Addendum 128 – UN Regulation No. 129

Revision 3 - Amendment 5

Supplement 6 to the 02 series of amendments – Date of entry into force: 3 January 2021

Uniform provisions concerning the approval of Enhanced Child Restraint Systems used on board of motor vehicles (ECRS)

Figure 2
ECRS Measurement Device - Side and Front View of the measuring device

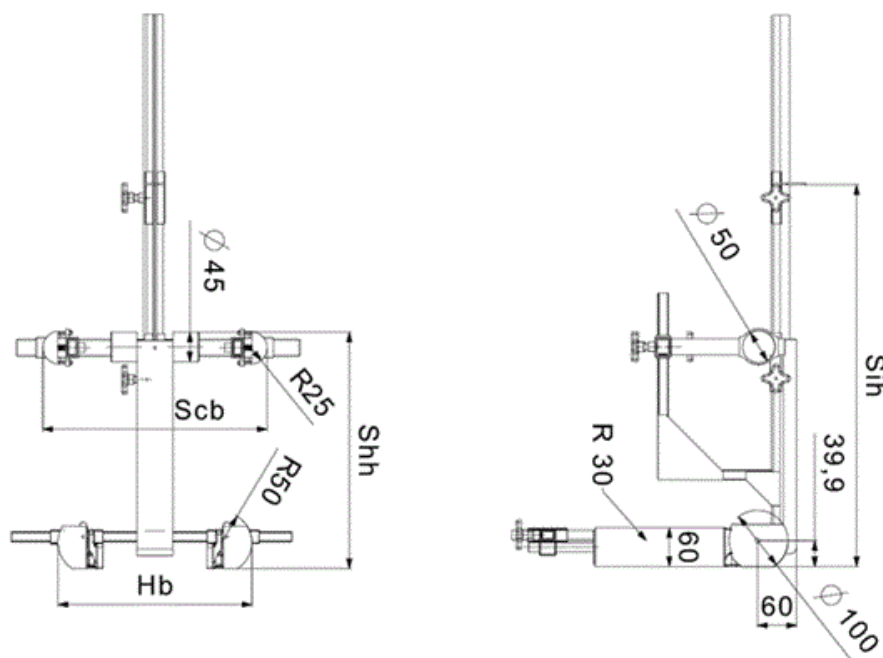
Annex 18, amend to read:

For integral or non-integral ECRS the device shown in Annex 18, Figure 2 shall be used.

The mass of the devices described in Figure 2 and Figure 3 shall be 10 kg +/- 1 kg.

All measurements shall be taken with the device base in contact with the seat pan of the ECRS and the device backrest in contact with the backrest of the ECRS. All lateral dimensions shall be measured under a contact force of 50 N with the devices described in Figure 2 and Figure 3 of this annex.

Figure 3
Side and Front View of the measuring device for measurements applicable to Enhanced Child Restraint Systems that feature an impact shield

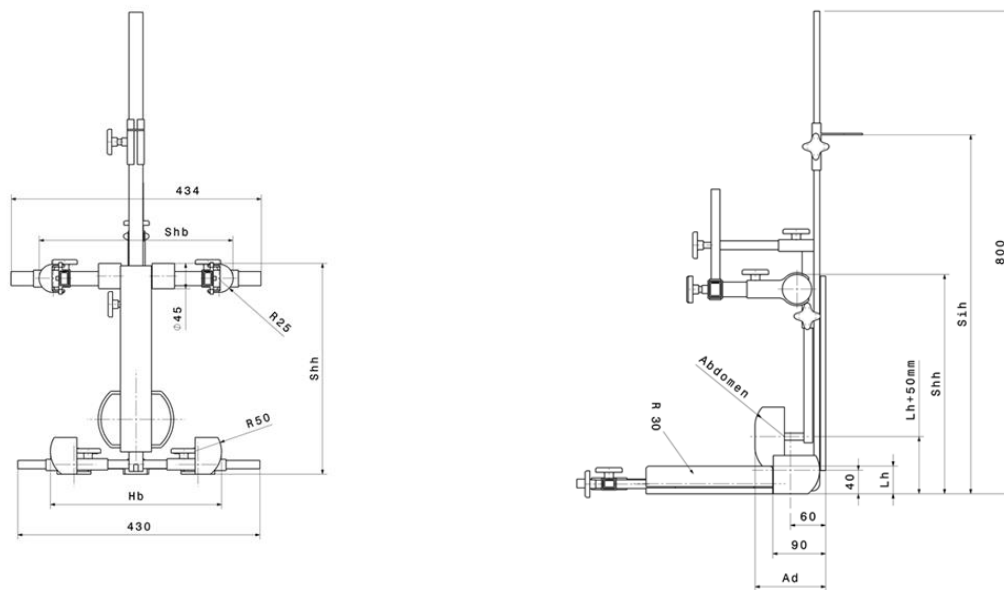
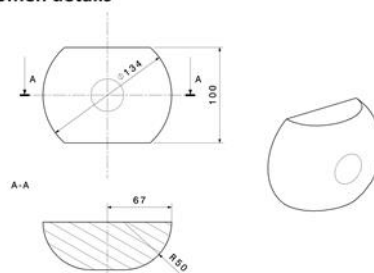
For ECRS with an impact shield the device shown in Annex 18, Figure 3 shall be used.
